**FINDINGS AND RECOMMENDATION  
OFFICE OF PLANNING AND ZONING  
ANNE ARUNDEL COUNTY, MARYLAND**

**CASE NUMBER:** 2025-0092-V

**REQUEST**

The applicant is requesting a variance to allow a dwelling with less setbacks than required on property located at 714 Bay Front Avenue in North Beach.

EXISTING CONDITIONS SITE PLAN

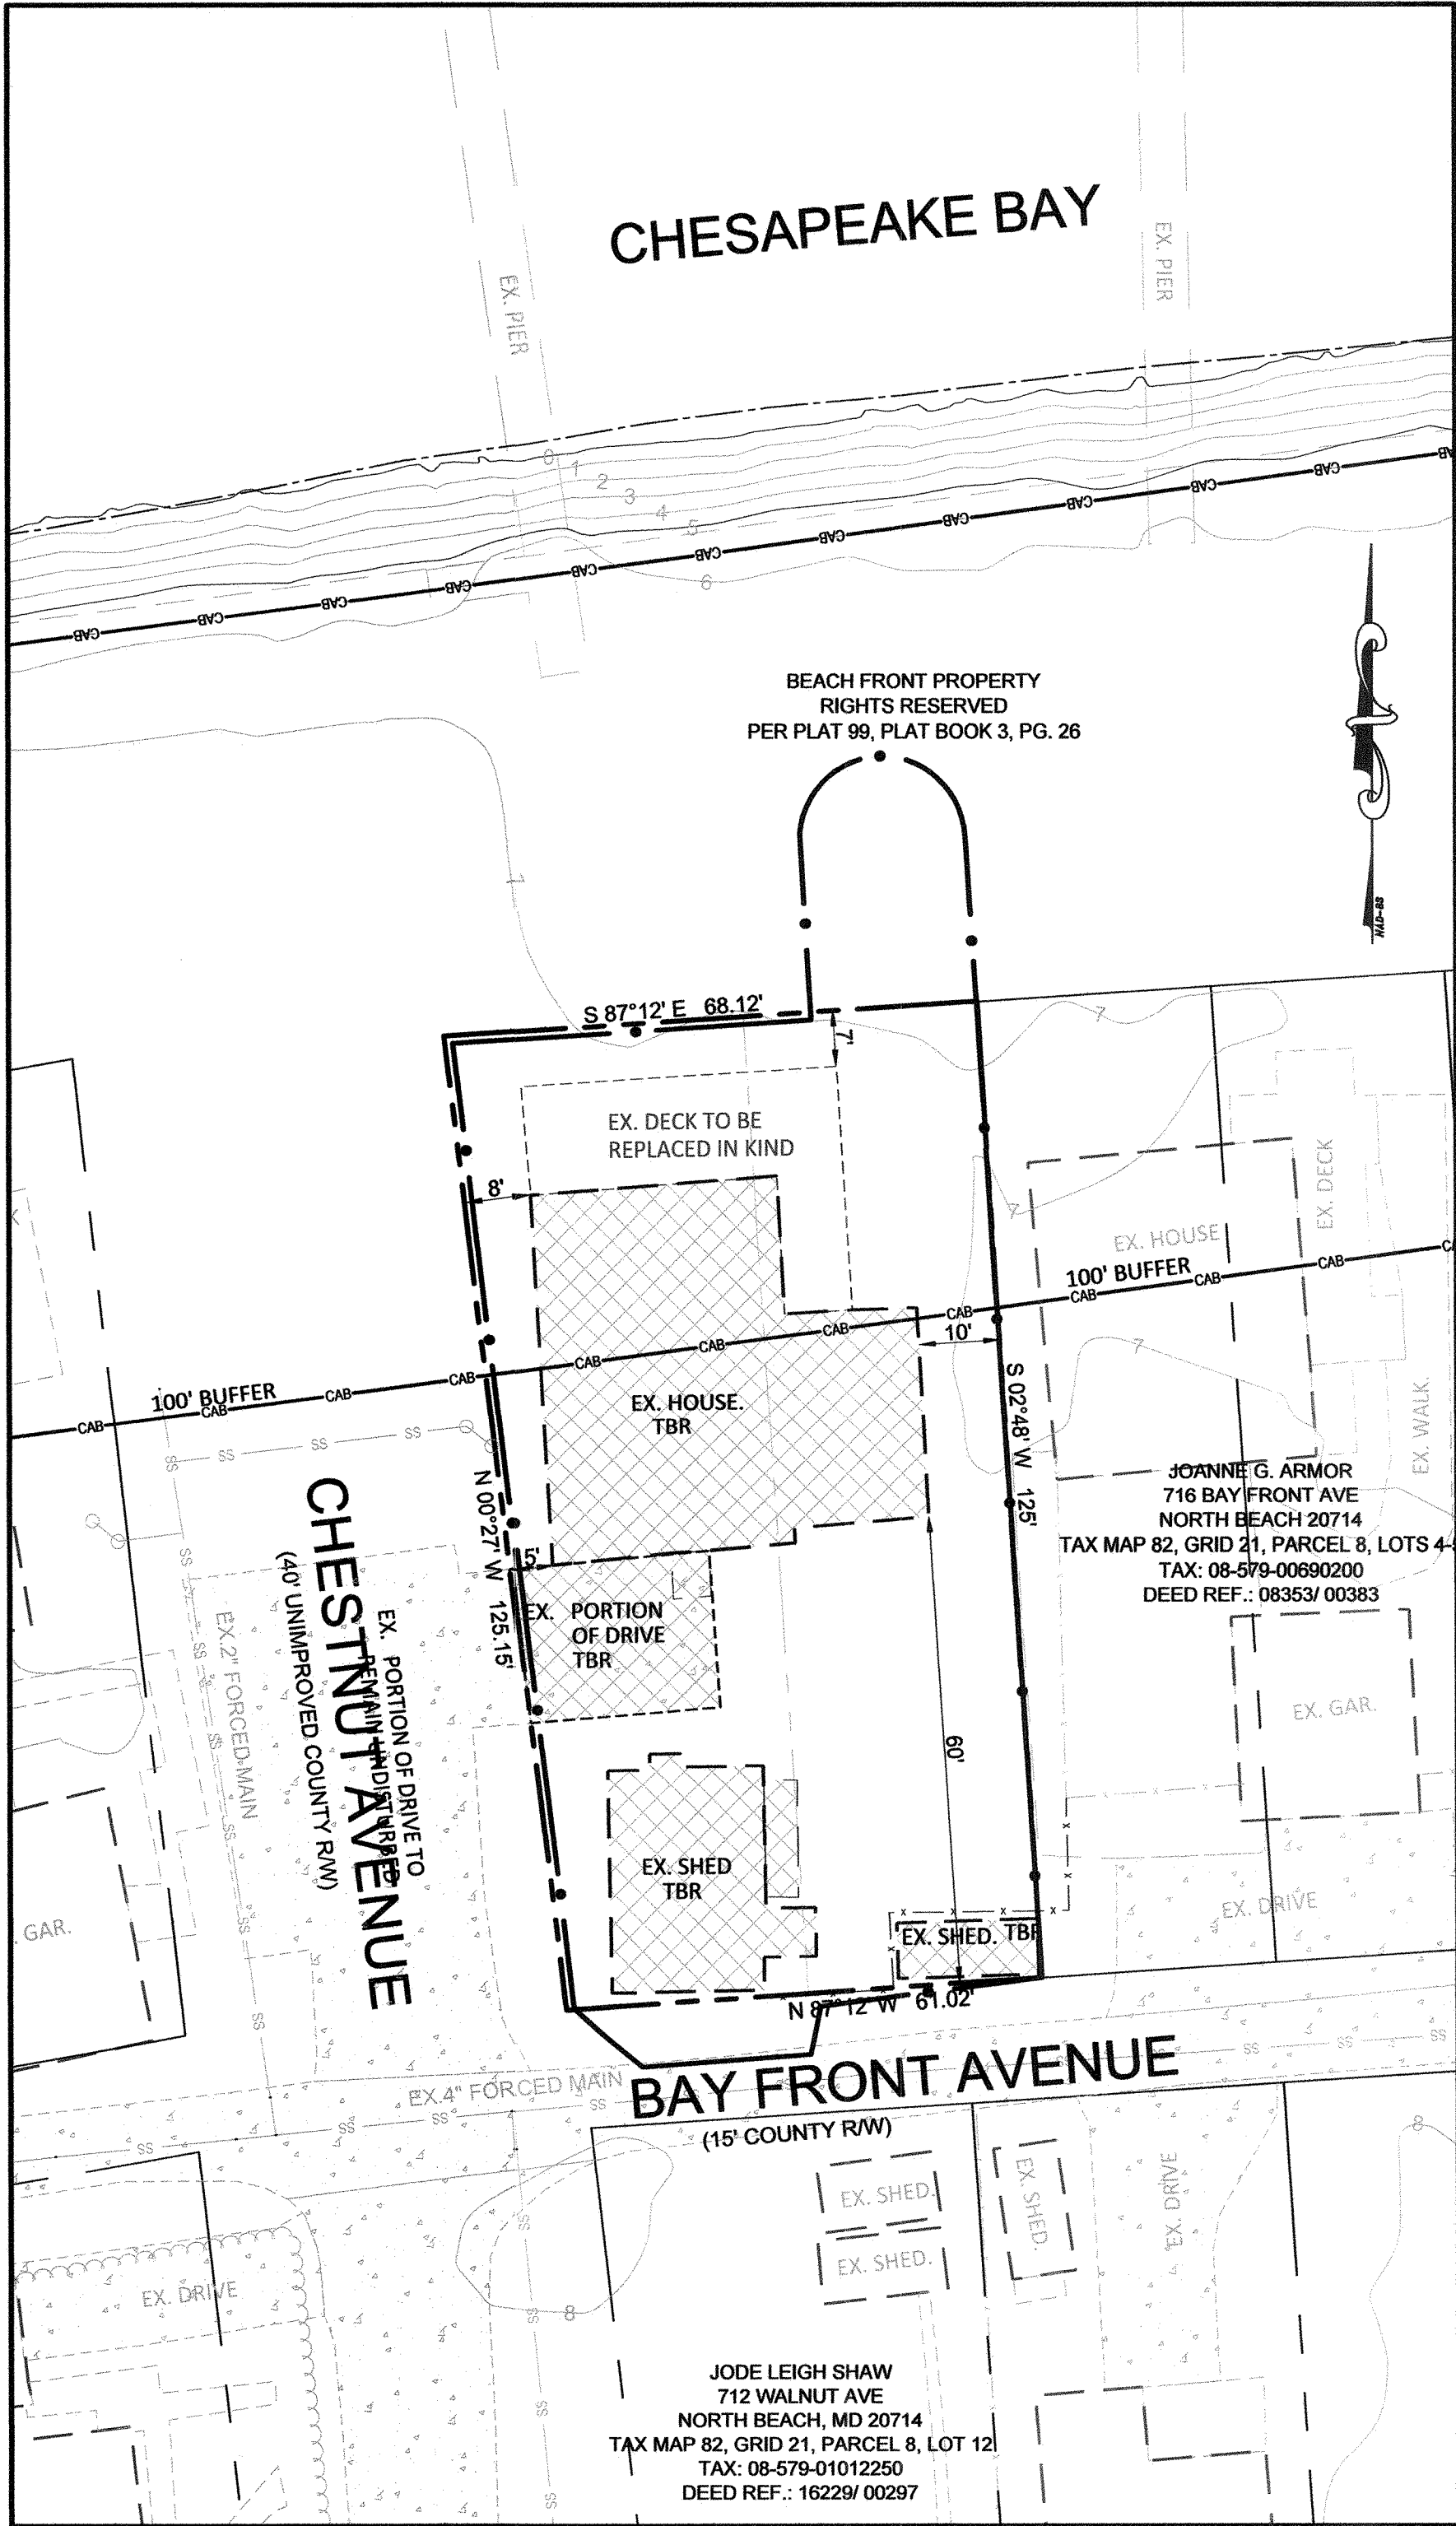
1. Show the existing well on the Existing Conditions Site Plan and state what is to be done with it.
2. Show the rooftop and non-rooftop disconnects on the Proposed Conditions Site Plan.

PROPOSED CONDITIONS SITE PLAN

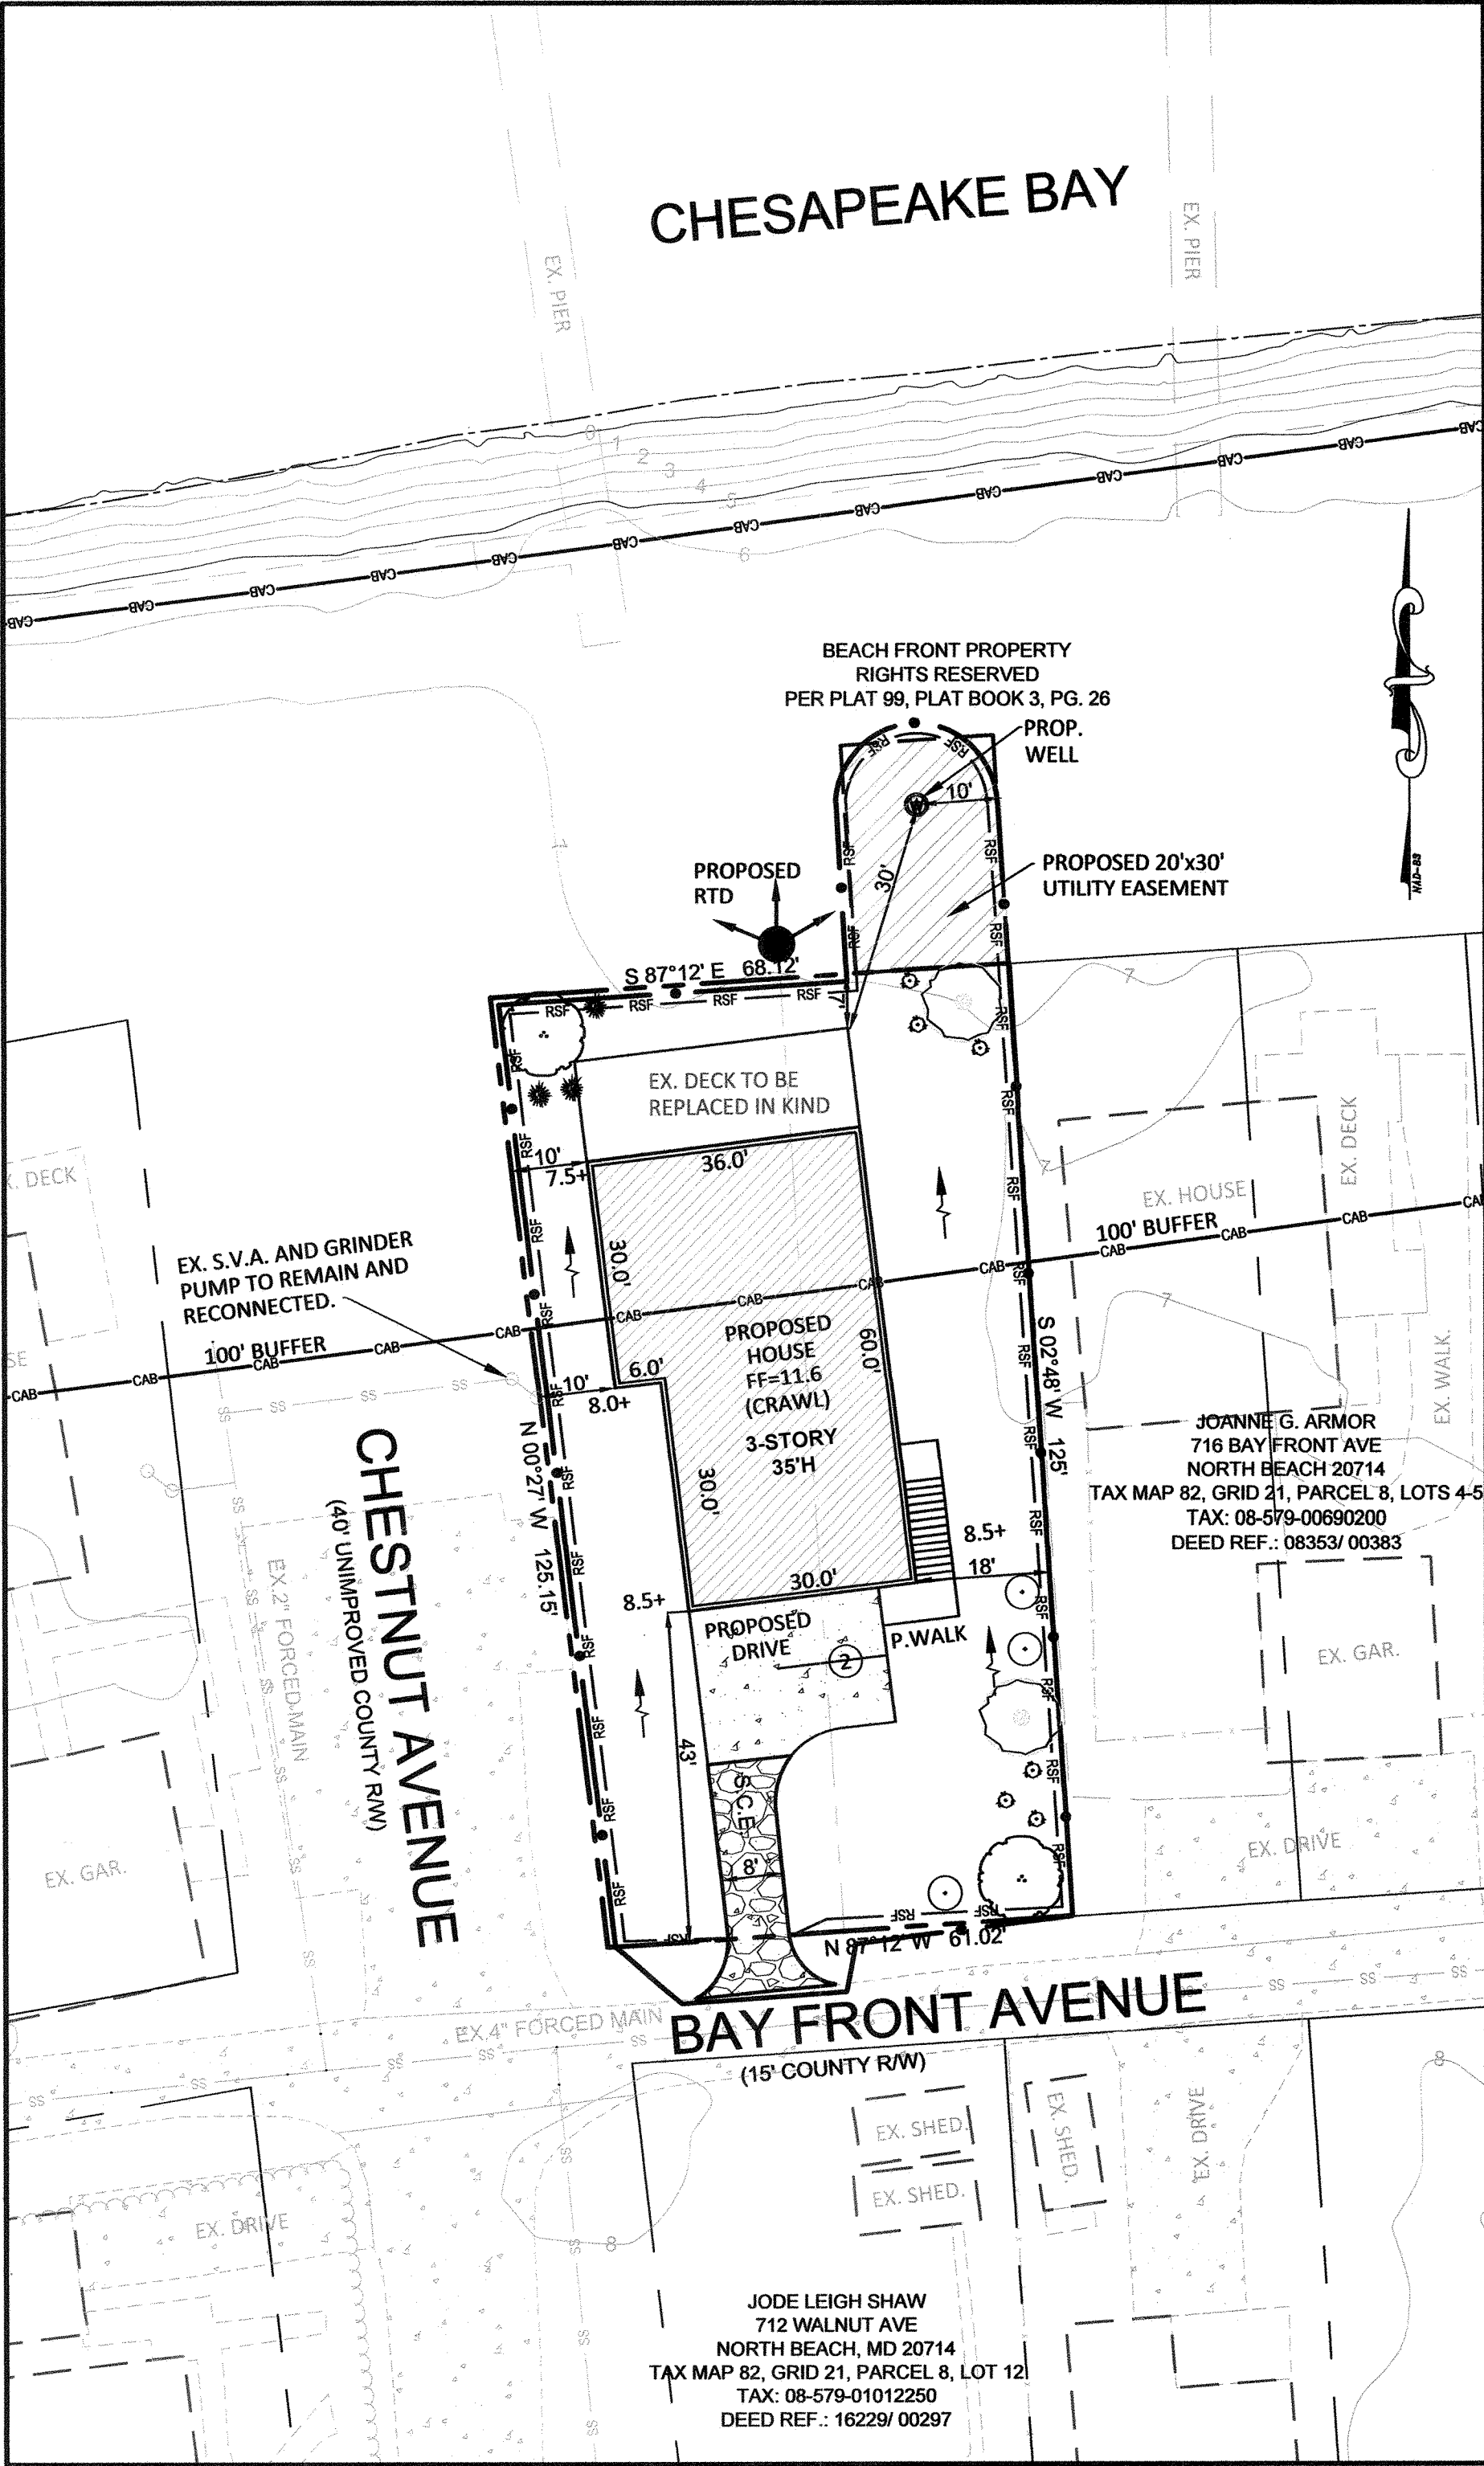
3. The proposed RTD needs to be on the property line. Revise at Grading Permit.
4. According to Geocortex, there appears to be an existing easement on the water side of the property for a grinder pump (Deed Book 7457, Page 028). At Grading Permit, clarify if the easement is still present. Note what is to be done with the easement. Provide appropriate setbacks for the grinder pump easement and the well. The deck is not permitted within the easement.
